**SAUSALITO-MARIN CITY SANITARY DISTRICT**  
**SCREW PRESS RELOCATION PROJECT**

**Addendum No. 1**

SCHEMATIC DIAGRAM OF PIPING CHANGES

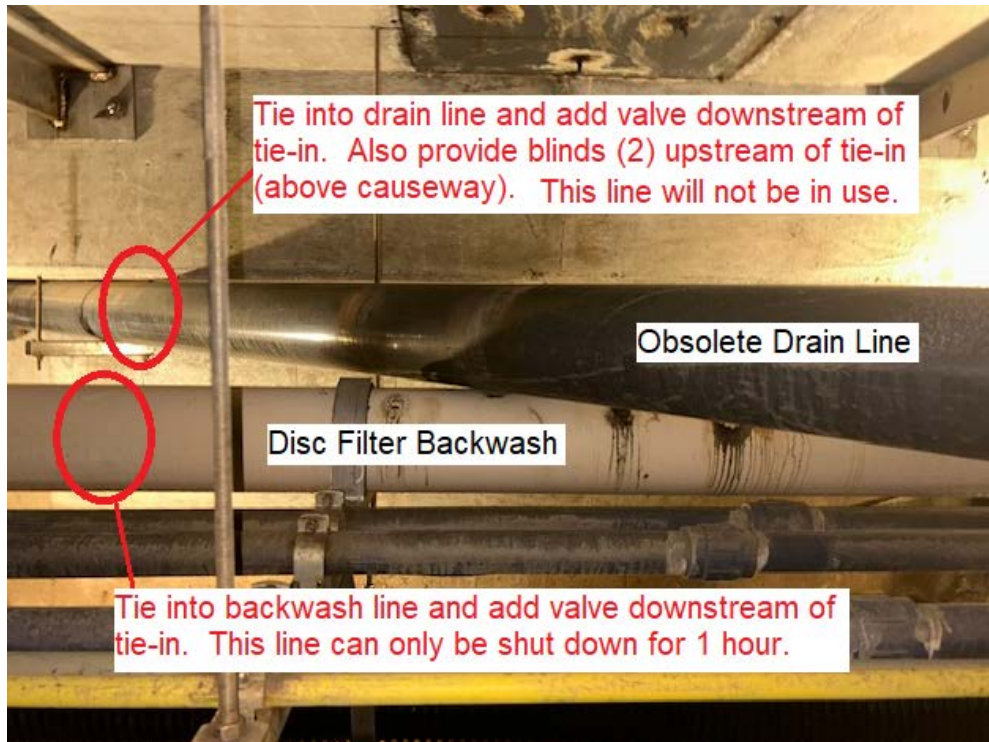
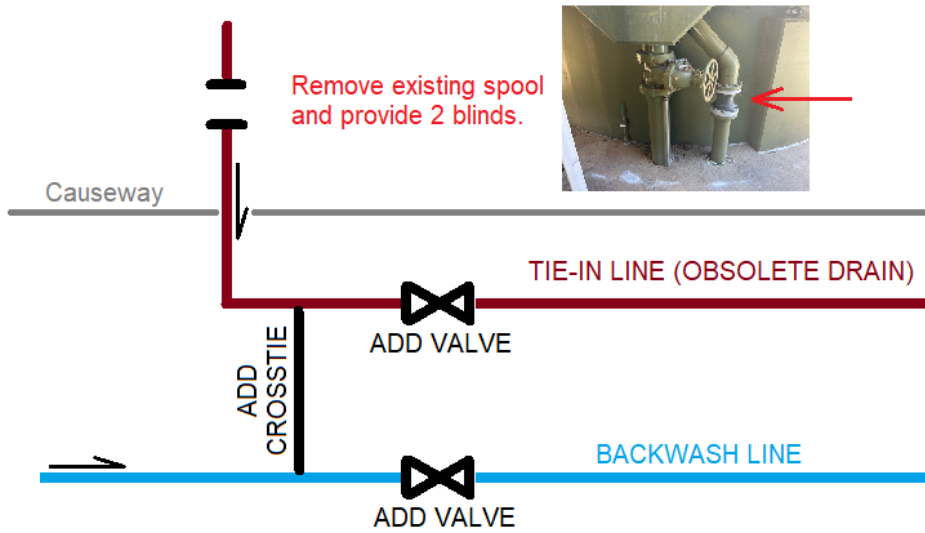
#### **Item 1.5: Piping Modifications under treatment plant causeway:**

Add one cross tie and two valves to allow diversion of disc filter backwash flow. Flow in this line can be stopped for no more than 1 hour. Consequently, a mechanical joint must be used for final tie-in. All piping other than the tie-in shall be solvent welded. All solvent welds must be allowed a 6 hour minimum cure time.

Valves and piping shall be supported with 316 SS pipe hangers. Provide support, including lateral support, at all valves and every 6' on piping. Anchor locations shall be field verified with the District in advance to avoid hitting conduits.

- Provide 2 plug valves for sewer service as specified in Section 15116.
- All piping shall be 6" Schedule 80 PVC.
- Mechanical Joint shall be Megalug with epoxy coating and 316 stainless steel hardware. Submit for approval in advance.
- Remove spool piece and provide 2 - 6" Schedule 80 PVC blinds on existing flanges. Location of spool is above the causeway (easy access). Return spool piece to District.
- All hardware shall be 316 SS.

This work shall be completed after the existing press location has been taken off-line. See photos for further details. Access under causeway is tight but accessible. All other piping under causeway must be protected from damage.
